MIXED USE DEVELOPMENT

1529 Creek Road, Carina

Noise Impact Assessment

Report
237401.0047.R01V04

Figure 6.1: Location and Extent of the Modelled Fixed Plant Noise Barriers

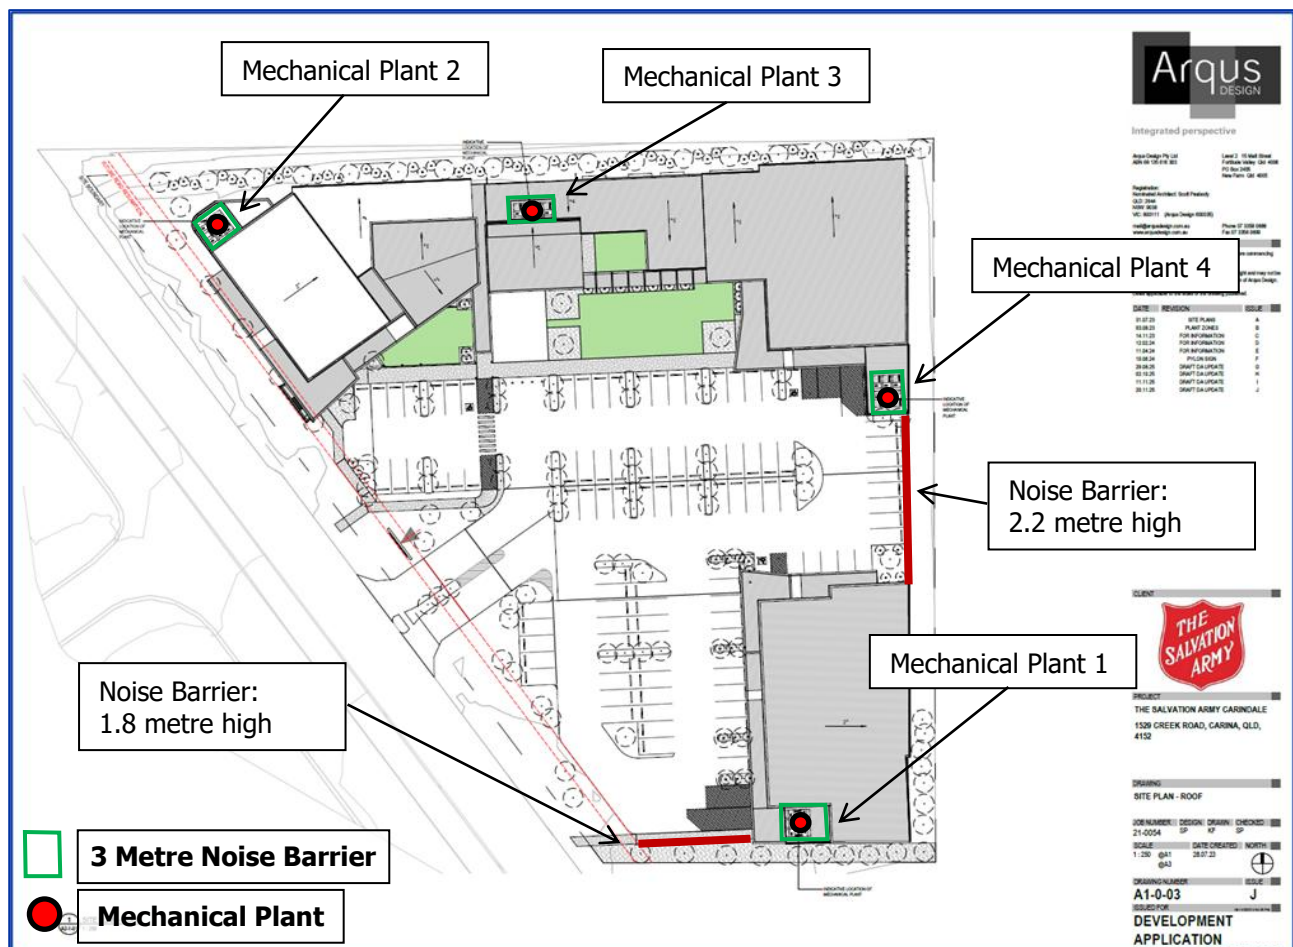
n) Submit section plans showing the acoustic barrier in context with the adjoining property	Proposed noise barrier locations are shown in Figure 6.1 . Section plan showing acoustic barrier proposed for one of existing noise sensitive receivers in context with the adjoining property is shown in Figure 6.2 .

The location and extent of the proposed noise barriers are shown in **Figure 6.1**.

It should be noted that the proposed 2.2 metre high noise barrier spans from construction stage 1 to stage 2 (refer to **Figure 3.2**); however, the entire barrier should be constructed at the outset of stage 1 to ensure effective noise mitigation for the carpark. Section plan showing this acoustic barrier in context with the adjoining property is also shown in **Figure 6.2**.
